Docket Item #2-A & B  
DEVELOPMENT SITE PLAN #2004-0005 (2-A)  
SUBDIVISION #2004-0005 (2-B)  
STREET NAME CASE #2004-0001 (2-A)  
OAK GROVE

Planning Commission Meeting  
May 6, 2004

**ISSUE:** Consideration of a request for a development site plan to subdivide the property into 10 lots, to construct single family homes and to name a new public street.

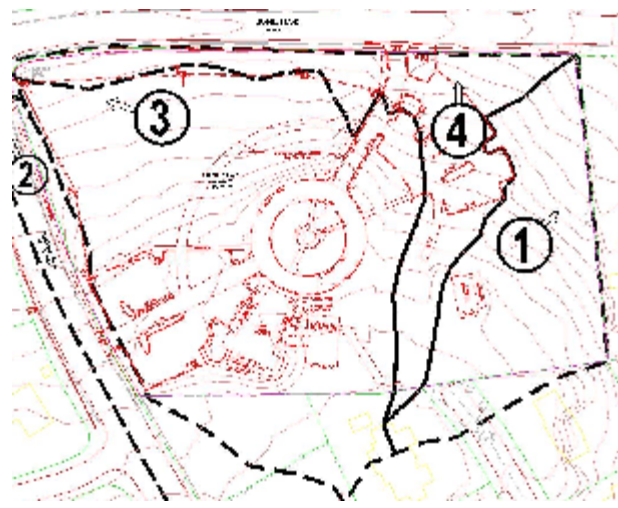
In addition to open space preservation, the application proposes to retain 22 of the existing trees. The site contains two existing historic oak trees on the southeastern portion of the site. These historic trees have been permanently protected by a covenant on the deed of the property. Both the developer and the new home purchasers are bound to protect and preserve these trees.

If the site plan is approved, then the trees shown on this plan as retained or relocated will have to be maintained. Staff is recommending conditions that prohibit disturbance within the dripline of canopy of all trees to be protected, and that the homeowners documents communicate to future purchasers that all trees shown as saved on the site plan must be retained. In addition to the saved trees, the applicant is proposing to plant 70 shade trees, 50 ornamental and evergreen trees, and 400 shrubs.

*Proposed Drainage Pattern Map*

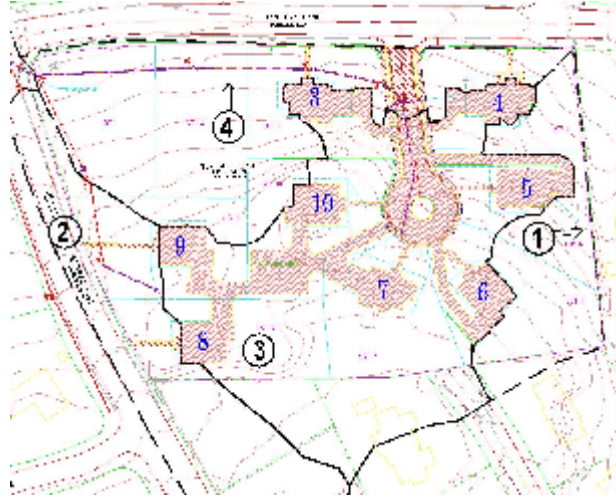
In the northern portion of the site, the existing runoff discharges through a flume into Janneys Lane, then flows in a westerly direction within Janneys Lane to an existing storm sewer system.

The eastern portion of the site sheet flows off-site across the property to the east and into Janneys Lane.

Under the development plan most of the site run-off from areas 1, 3 and 4 will be collected by underdrains, roof drains and storm sewer to convey the surface run-off to an existing underground storm sewer conveyance system. This will substantially reduce the existing surface run-off sheet flowing off-site. Stormwater management detention practices will be implemented, if necessary, to make sure that the proposed run-off will not exceed the existing run-off flowing into the existing storm sewer system.
